## Application to amend licence

**Works approval number** L6420/1988/14

**Licence holder** Kalgoorlie Consolidated Gold Mines Pty Ltd

**Premises** Fimiston Plant and Tailings Storage Facilities

Figure 1: Kaltails compliance zones in Existing Licence L6420/1988/14

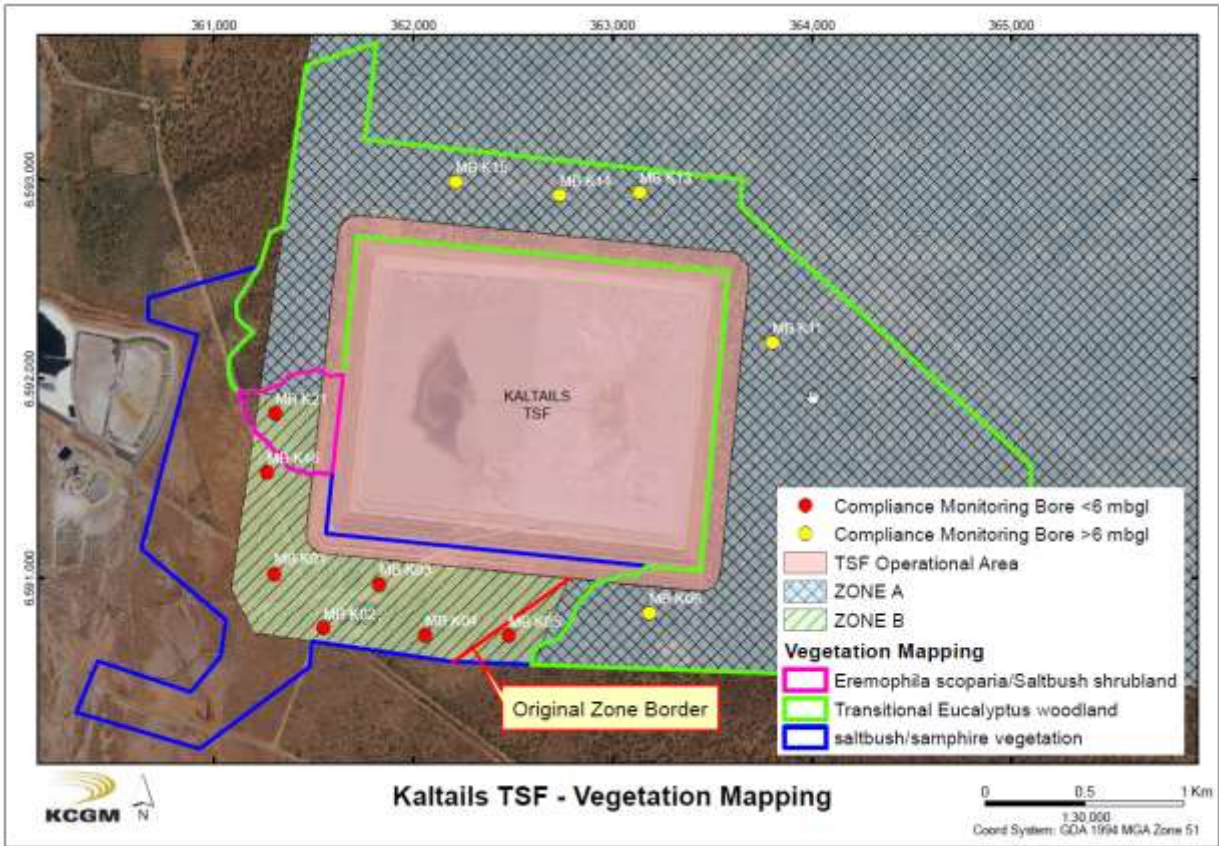
Management of seepage impacts and seepage recovery in the area adjacent to the Kaltails TSF is currently managed via the KSGMP, which is conditioned in the Existing Licence via condition 1.3.5. Two groundwater limits (with corresponding action trigger points) apply in the licence; a 1 mbgl limit for zone B in the area to the south west of the TSF and 4mbgl in the remaining perimeter area adjacent to the TSF (zone A –Figure 1). These limits are in response to the local geology at these locations (with background groundwater levels naturally elevated at Zone B) and also intended to be reflective of the root zones of vegetation that occur in each zone (Zone B has shallow rooted vegetation).

The Licence Holder contends in their amendment application that the zones would be more reasonable defined such that MB K05 falls within zone B. This is supported by data in the application showing natural and current ground water levels (with ongoing pumping) to be around 5mbgl.

The potential risk in moving the zone boundary is that if deeper rooted vegetation fall into zone B, the shallower allowable depth to groundwater may not be sufficient to keep the saline groundwater out of the root zone, leading to vegetation stress or death. However vegetation mapping was provided by the Licence Holder on 23 January 2020 (KCGM 2020b) (Figure 2) showing the proposed zone boundary relative to vegetation communities, as surveyed in 2009 by Botanica Consulting. This showed that the proposed zone boundary aligns more closely with the vegetation communities than the existing zone boundary, and that MB K05 falls within the region of shallow rooted saltbush/samphire vegetation; which is consistent with the rest of Zone B.

The Delegated Officer considers that as the monitoring data presented is consistent with a natural groundwater level around 5m and the vegetation mapping shows that MB K05 is within the mapped vegetation community characterising Zone B, it is reasonable to redefine the zone boundary as requested to place MB K05 within zone B, rather than zone A.
